Metro Outer Development Assessment Panel Agenda

Part B – Item 3.1 – LOT 827 (NO. 21) INJUNE WAY, JOONDALUP – EDUCATIONAL ESTABLISHMENT

Form 1 – Responsible Authority Report (Regulation 12)

Figure: 5 Vegetation Classification

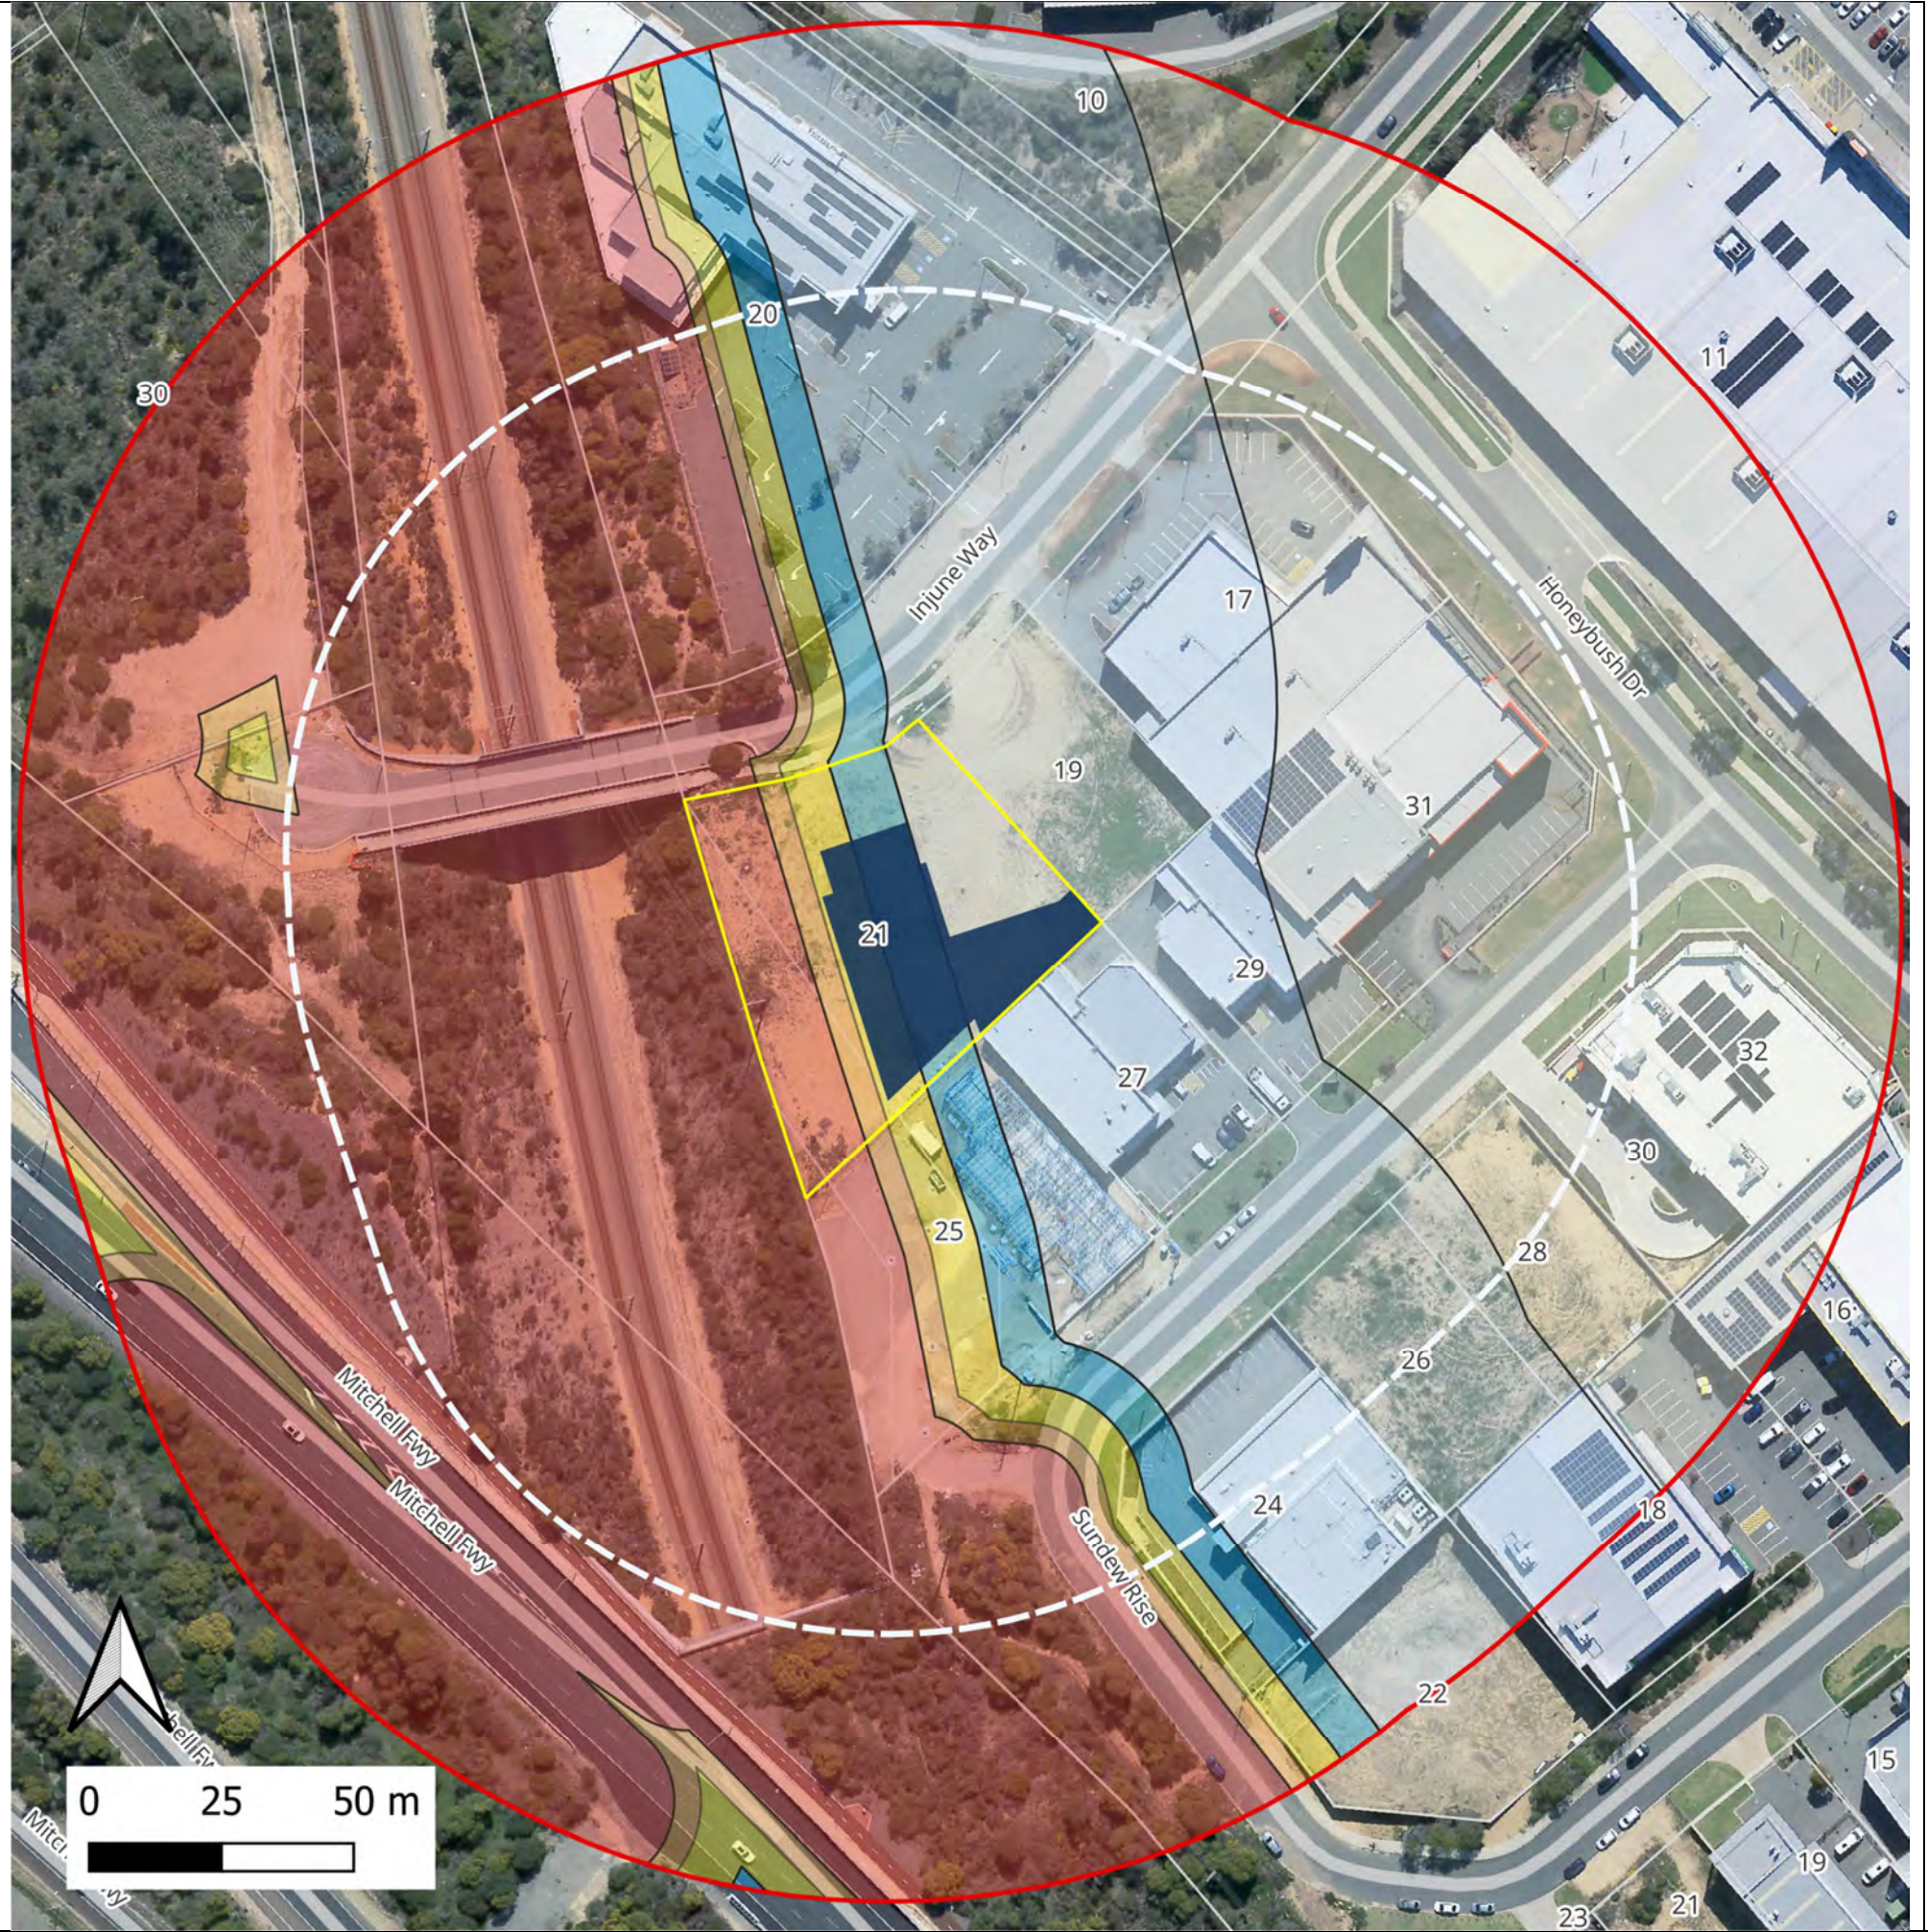
Vegetation Classification or Exclusions	BMP Modification Required
<u>Classified Vegetation – not demonstrated</u> As noted above, the vegetation assessment map (figure 5) does not provide labels for all areas, and the boundaries of each plot are not clear, leaving it unclear which slope has been applied to each plot. Further, the slopes applied to not align with slopes measured from the topographic contours, and insufficient evidence is provided to validate the maximum heights of vegetation within some areas classified as Class D Scrub (including the area directly abutting the development site). On the basis of the above issues, DFES is unable to validate the vegetation inputs or BAL outputs. Further information is required to validate the inputs before a BAL rating can be validated. DFES notes that as the planning stage will determine the location of the building, it is imperative that the above issues are resolved, and an accurate BAL rating can be assessed prior to any approval being issued. It is noted that any slope greater than 20% (as potentially present in this area) cannot be assessed using Method 1. Transects are present abutting the site detailing 10 metre drops over less than 25 metres present (>20 degree slope). It is noted that the BMP labels this area as 11 degrees only, which cannot be accurate given the above measurements. It is noted that this area is key to ensuring an accurate BAL contour is provided to determine where the building should be located (which will impact the potential building layout/location). The vegetation classification/slopes should be revised (and substantiated with further evidence) as per AS 3959, or the resultant BAL ratings will be inaccurate.	BAL Rating cannot be validated. Further evidence to support the vegetation classification/slope of several plots is required.

Figure: 5 Vegetation Classification

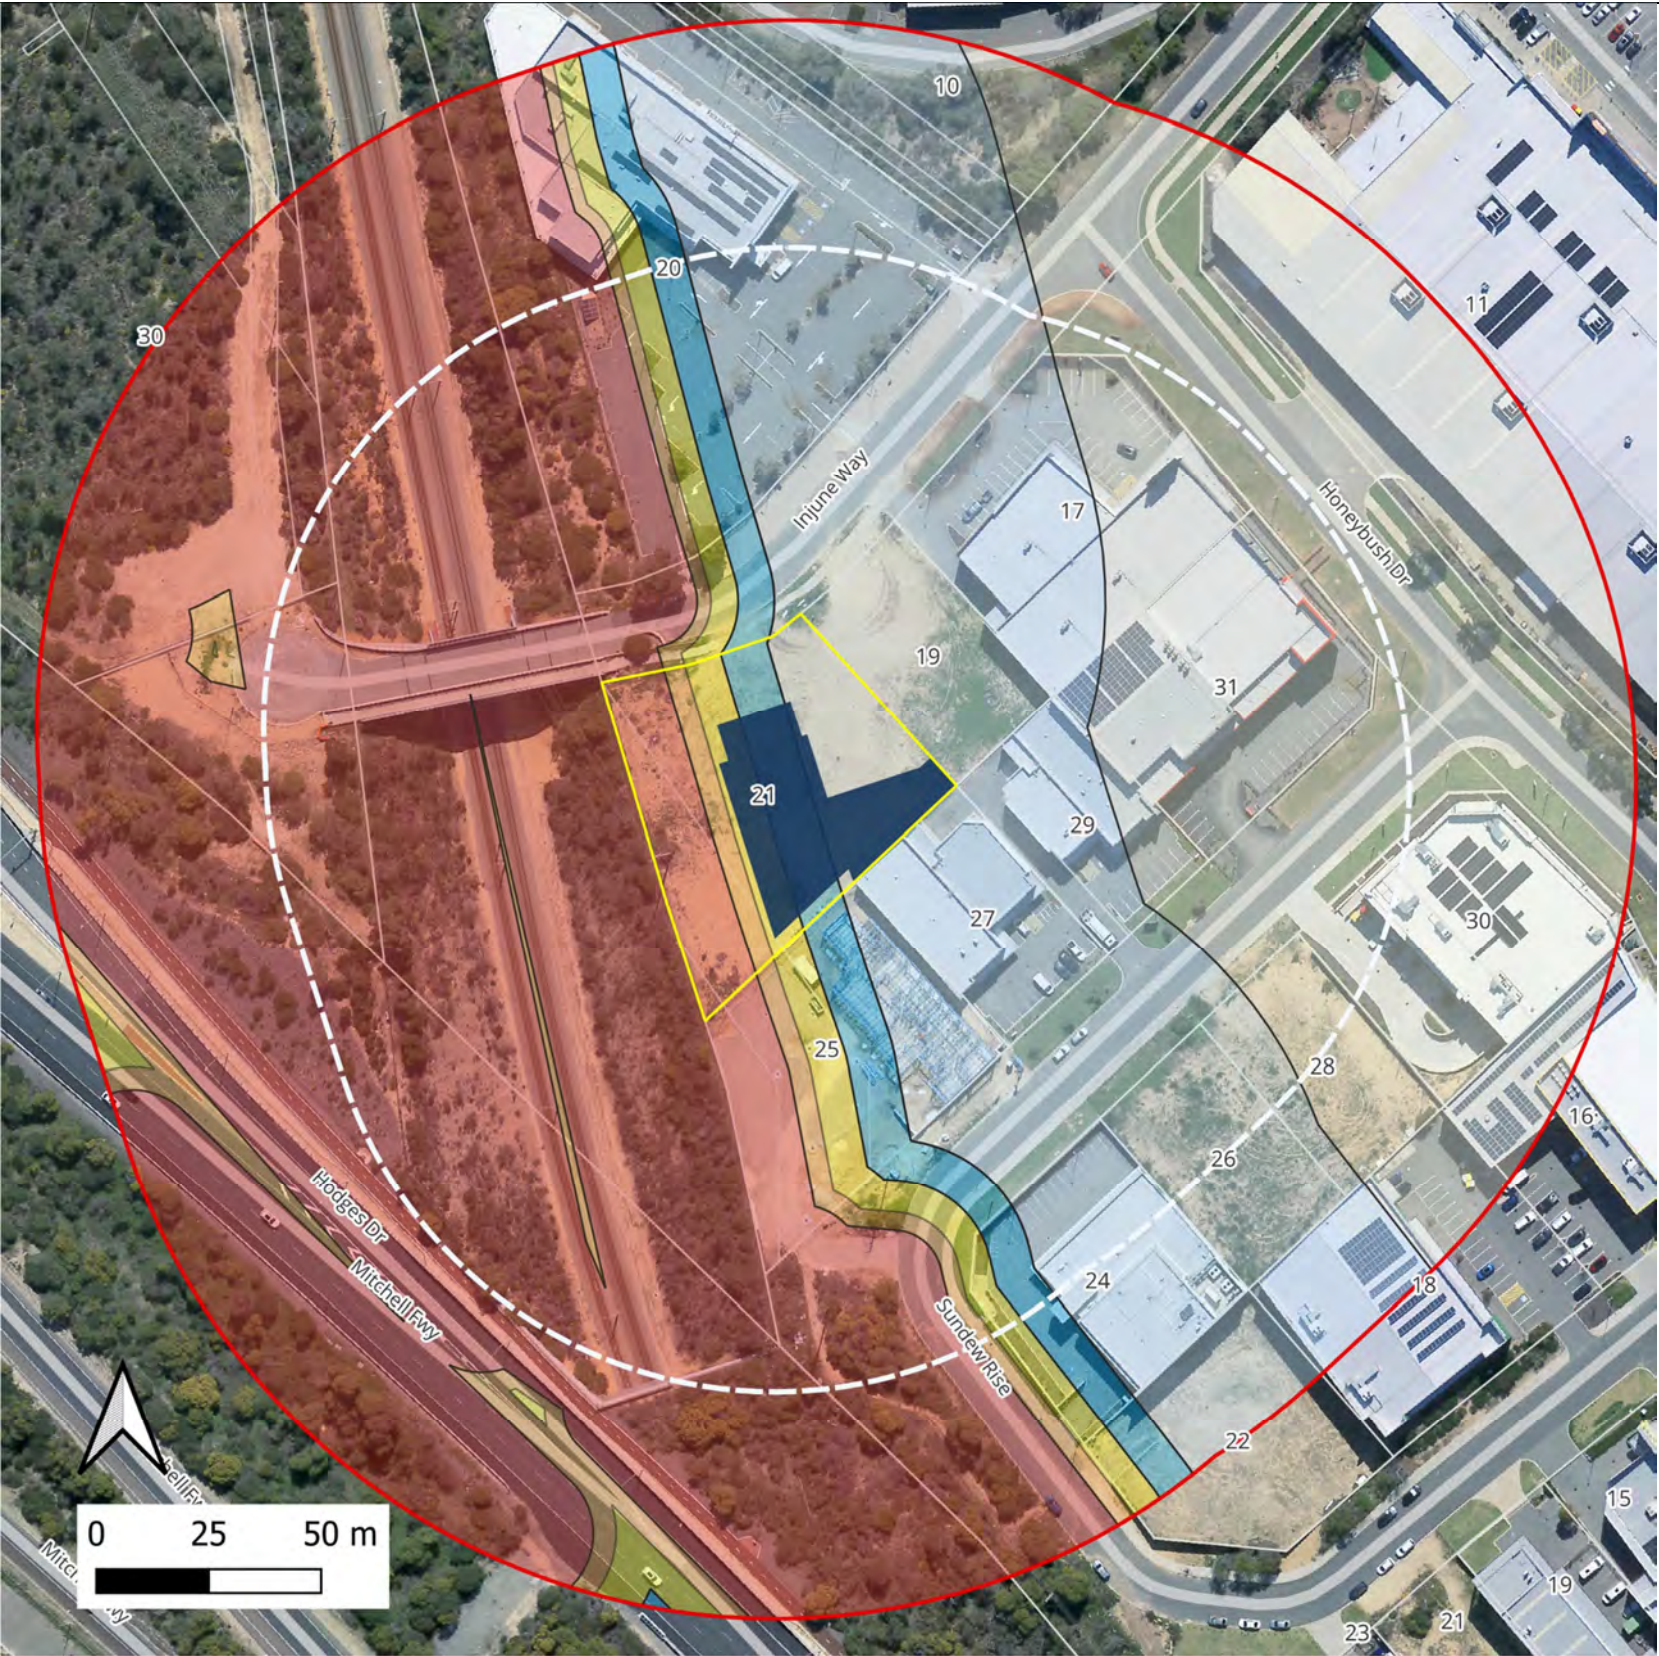
DFES Comment	Bushfire Smart Response
Classified Vegetation – not demonstrated As noted above, the vegetation assessment map (figure 5) does not provide labels for all areas, and the boundaries of each plot are not clear, leaving it unclear which slope has been applied to each plot. Further, the slopes applied to not align with slopes measured from the topographic contours, and insufficient evidence is provided to validate the maximum heights of vegetation within some areas classified as Class D Scrub (including the area directly abutting the development site). On the basis of the above issues, DFES is unable to validate the vegetation inputs or BAL outputs. Further information is required to validate the inputs before a BAL rating can be validated. DFES notes that as the planning stage will determine the location of the building, it is imperative that the above issues are resolved, and an accurate BAL rating can be assessed prior to any approval being issued. It is noted that any slope greater than 20% (as potentially present in this area) cannot be assessed using Method 1. Transects are present abutting the site detailing 10 metre drops over less than 25 metres present (>20 degree slope). It is noted that the BMP labels this area as 11 degrees only, which cannot be accurate given the above measurements. It is noted that this area is key to ensuring an accurate BAL contour is provided to determine where the building should be located (which will impact the potential building layout/location). The vegetation classification/slopes should be revised (and substantiated with further evidence) as per AS 3959, or the resultant BAL ratings will be inaccurate.	Overall plots have been simplified, and colour contrast increased to ensure clarity. It is agreed that the slopes are in excess of 20° for plot 2, this has been corrected within the BMP and a Method 2 assessment has been calculated. Photos for plot 2 show a fence that is 1800mm high. This acts as a height guide for vegetation and demonstrates that the vegetation within plot 2 is less than 2 metres. There is an isolated bush that is greater than 2 metres high, however this is where the terrain is flat, and the plot has been assessed in accordance with AS3959:2018 with due regard to clause 2.2.3.1 Note1: 'Classification should not be based solely on the edge of the vegetation'
